# FACPAC Contract Change Order Supplemental Information Form (Ref# 56039)

Tier 1 Project: ECHS Renovation Phase #7

PR #9 - Changes in the gym lobby and adjacent ticket booth which shall become a Concessions area. Refer to

Drawings PR9.1 and PR9.2 and MEP - PR9 Mechanical, PR9 Electrical. Extended schedule 20 working days or 28 calendar days

PROPOSAL REQUEST #9  
ESTILL COUNTY HIGH SCHOOL PHASE 7 RENOVATIONS

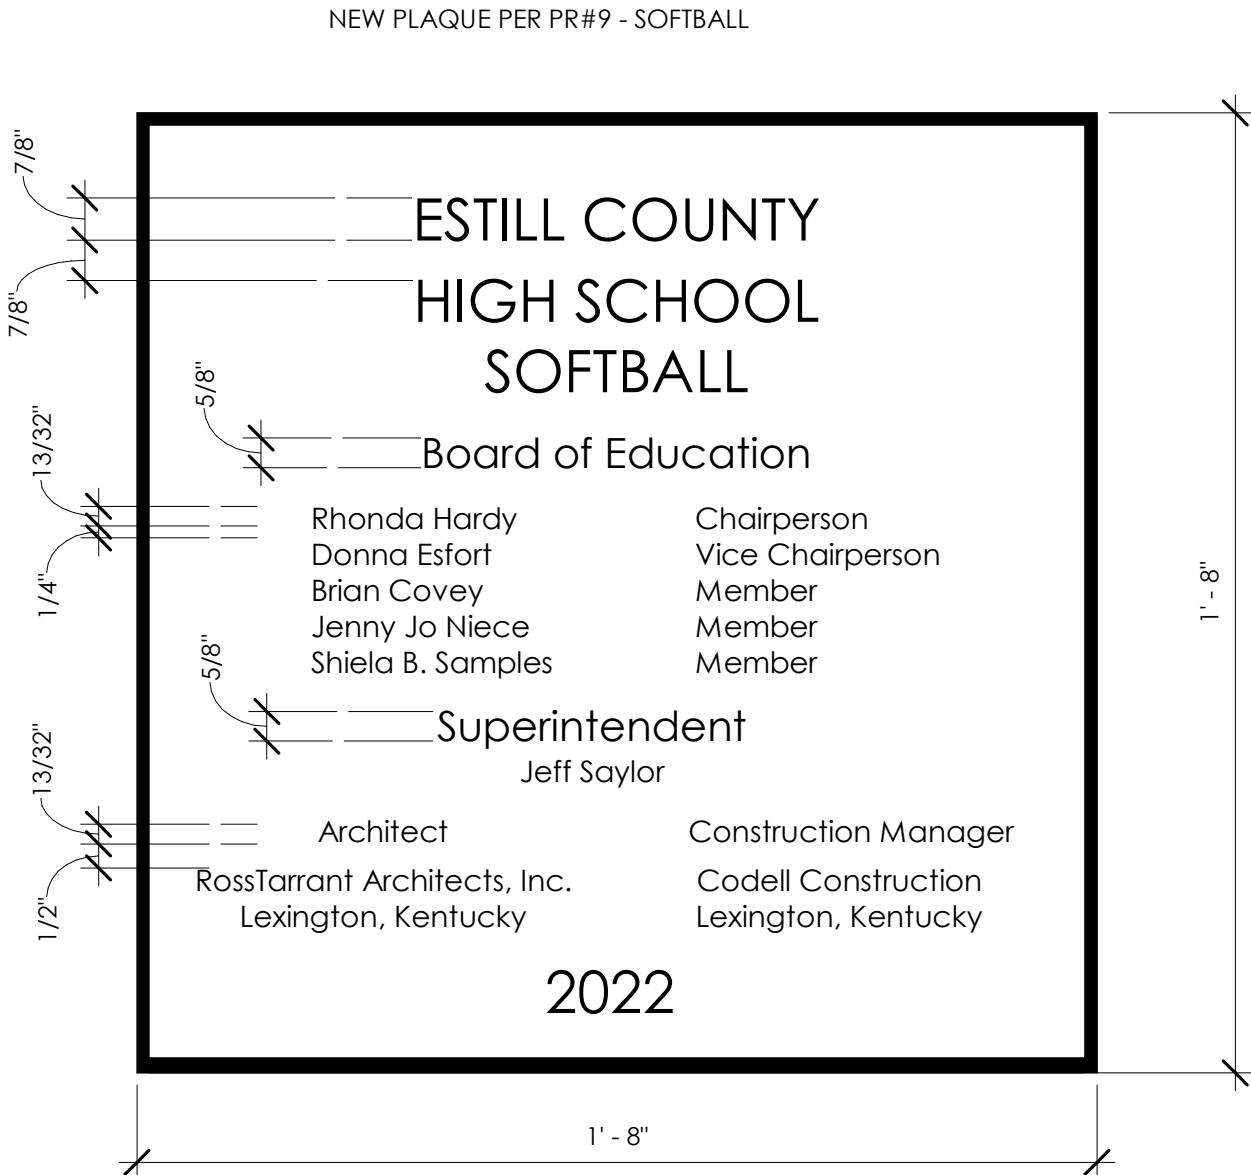
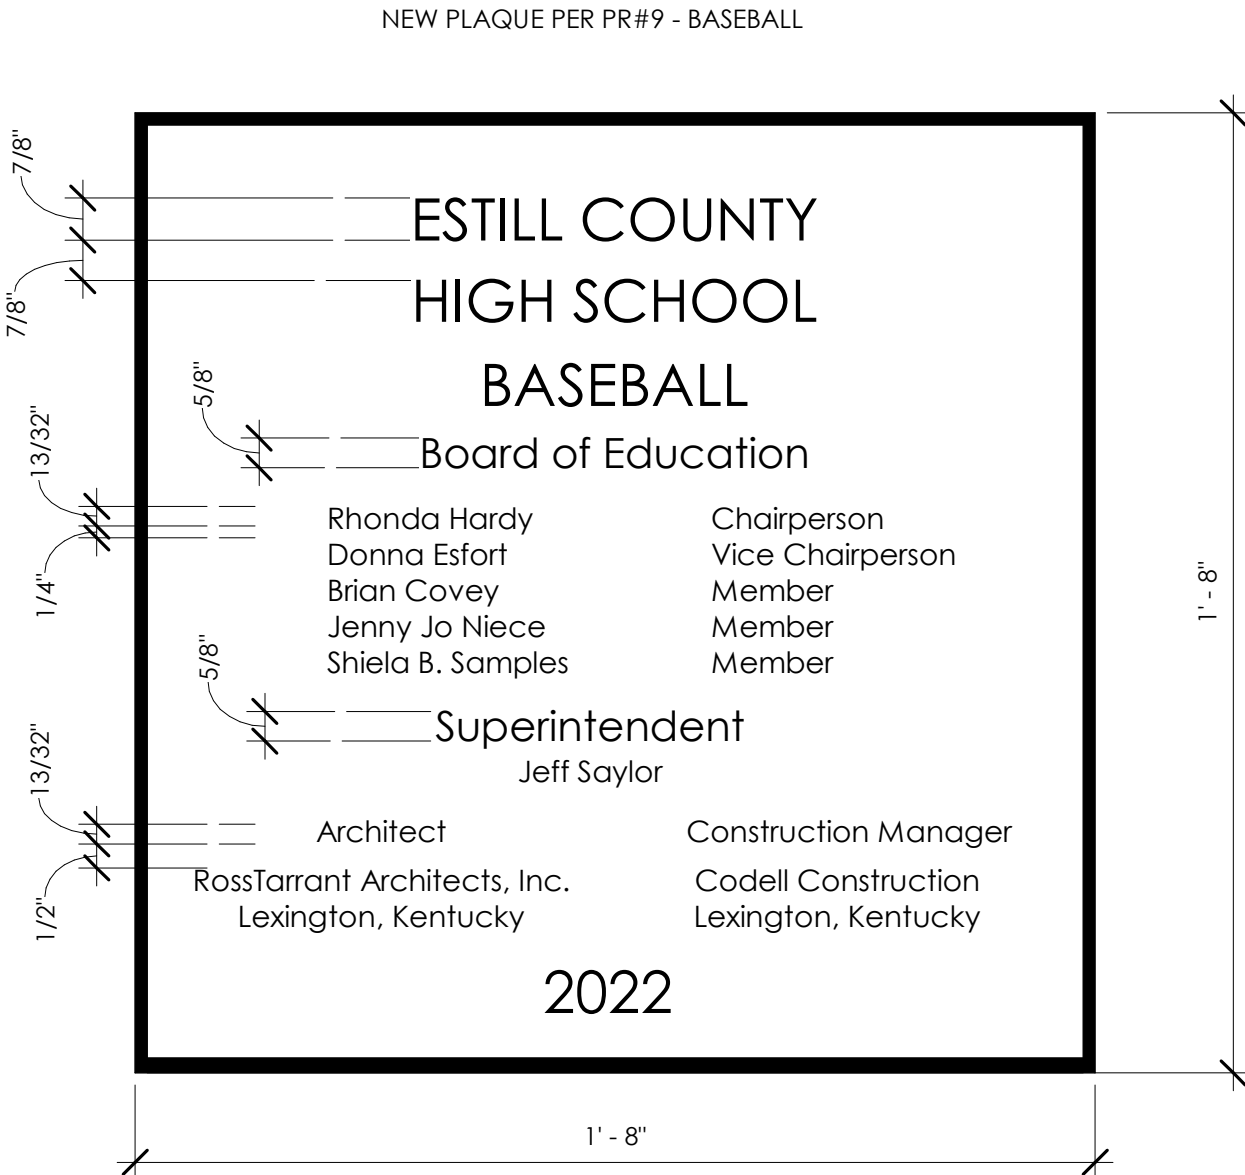
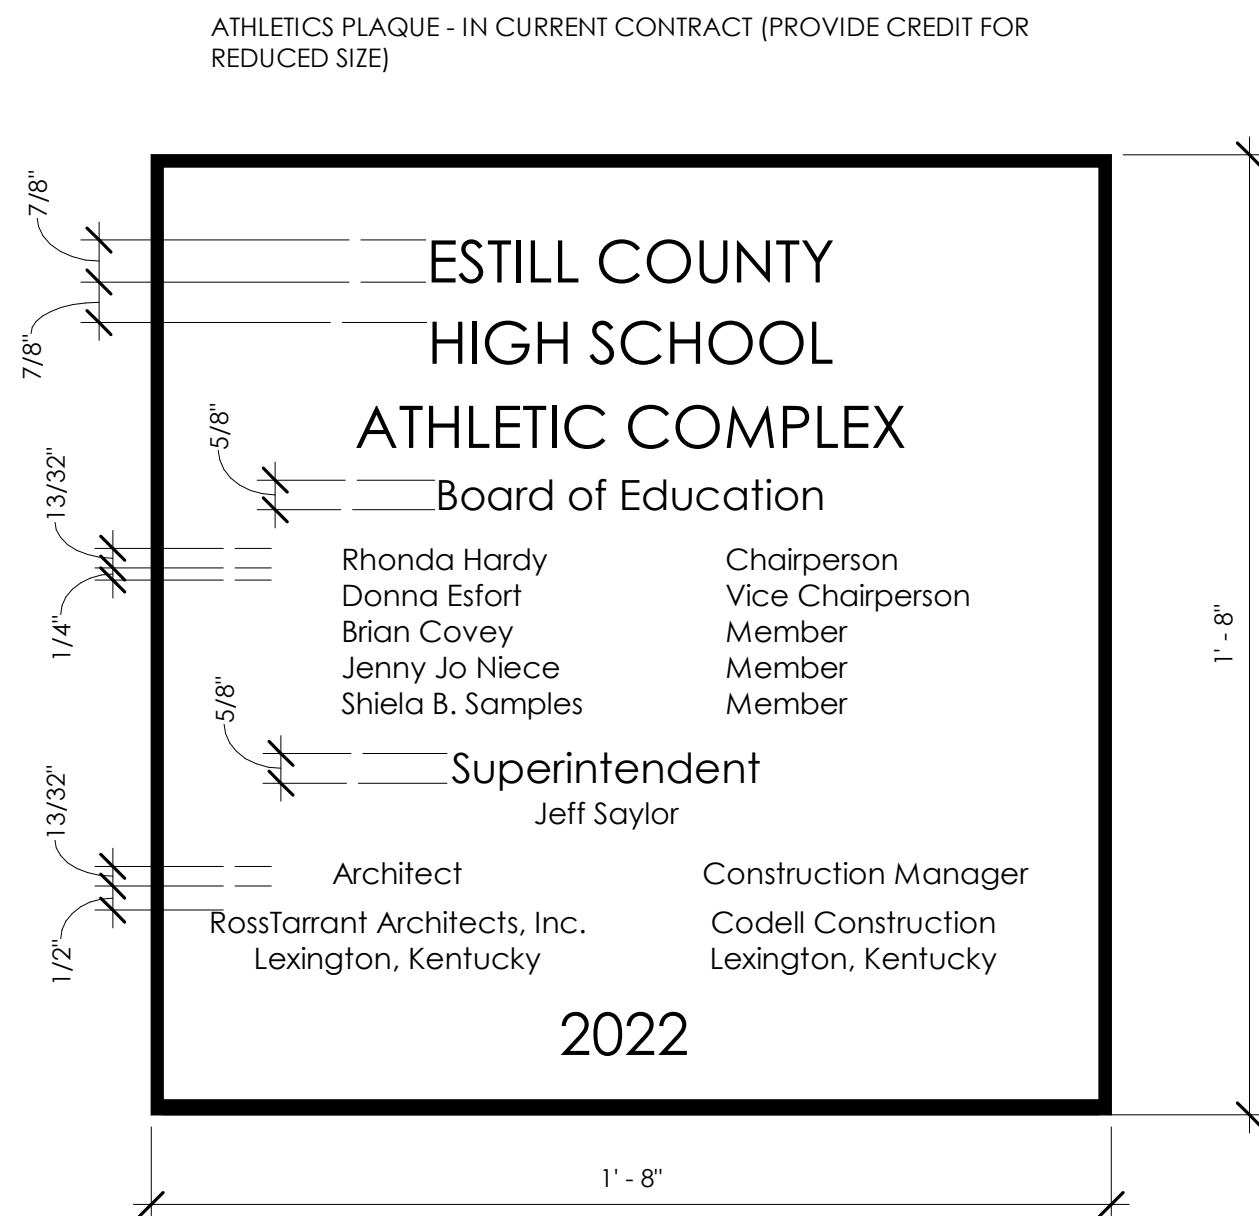
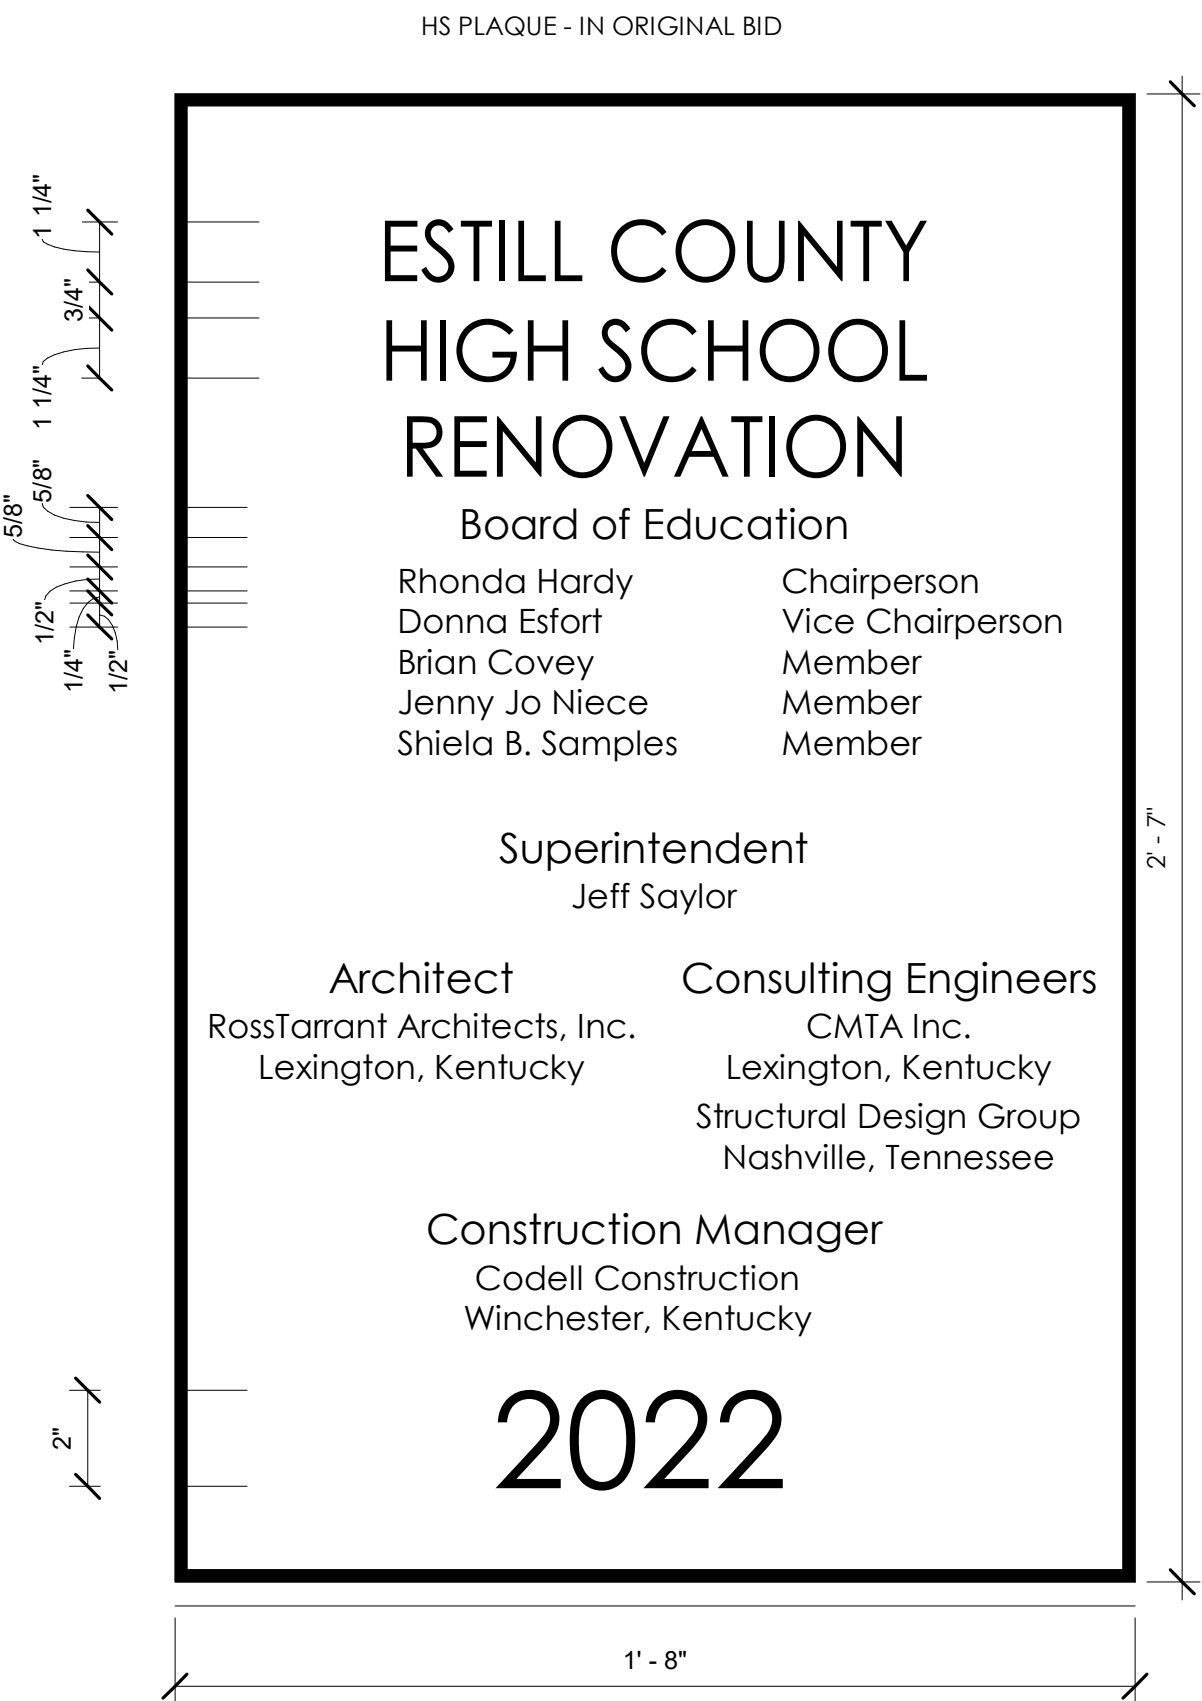
PR #9 RCP NOTES	
1	GYPSUM BOARD CEILING. PROVIDE FRAMING AND SUPPORTS AS REQUIRED (092116)..
2	SCRUBBLE FACE 2X2 CEILING TILE..
3	UTILITY CHASE..

PR #9 PLAN NOTES	
1	PATCH AND REPAIR WALL AS REQUIRED. REFER TO INTERIORS FOR ADDITIONAL INFORMATION.
2	TOOTH IN CMU AND HONOR LINTEL ABOVE. PROVIDE NEW DOOR AT 180 SWING TO FIT IN OPENING AS SHOWN
3	COORDINATE STUD PLACEMENT WITH ELECTRICAL PANEL. REFER TO MEP DWGS FOR ADDITIONAL INFORMATION.

<b>CEILING DEMOLITION NOTES:</b>	
C-1	REMOVE EXISTING CEILING TILE & GRID IN ITS ENTIRETY.
<b>DOOR/DOOR THRESHOLD DEMOLITION NOTES:</b>	
D-1	REMOVE EXISTING METAL FRAME, DOOR[S], AND GLAZING IN ENTIRETY. REFER TO PLANS FOR NEW WORK.
<b>FINISH DEMOLITION NOTES:</b>	
F-1	REMOVE EXISTING RESILIENT FLOORING & BASE IN THE ENTIRETY.
<b>MISCELLANEOUS DEMOLITION:</b>	
M-1	REMOVE COILING DUCT AT THIS LOCATION IN ITS ENTIRETY.
M-2	REMOVE EXISTING MECHANICAL UNIT IN ITS ENTIRETY. PATCH AND REPAIR SURFACES TO RECEIVE NEW WORK. REFER TO MECHANICAL DRAWINGS FOR ADDITIONAL INFORMATION.
M-3	REMOVE EXISTING WORK IN ALL ITS ENTIRETY. PATCH AND REPAIR SURFACES TO RECEIVE NEW FINISHES. COORDINATE WITH NEW WORK. REFER TO MEP FOR ADDITIONAL INFORMATION.
M-4	REMOVE EXISTING PLUMBING FIXTURE IN ITS ENTIRETY. PATCH AND REPAIR SURFACES TO RECEIVE NEW WORK AS REQUIRED. REFER TO MEP FOR ADDITIONAL INFORMATION.
M-5	REMOVE EXISTING LOBBY DISPLAY CASE INCLUDING FLOOR MOUNTED RAILING, MASONRY DISPLAY SURROUND, WOOD TRIM AND DISPLAY CASES, SALVAGE CASE SHELVING AND BRACKETS TO BE TURNED OVER TO OWNER.
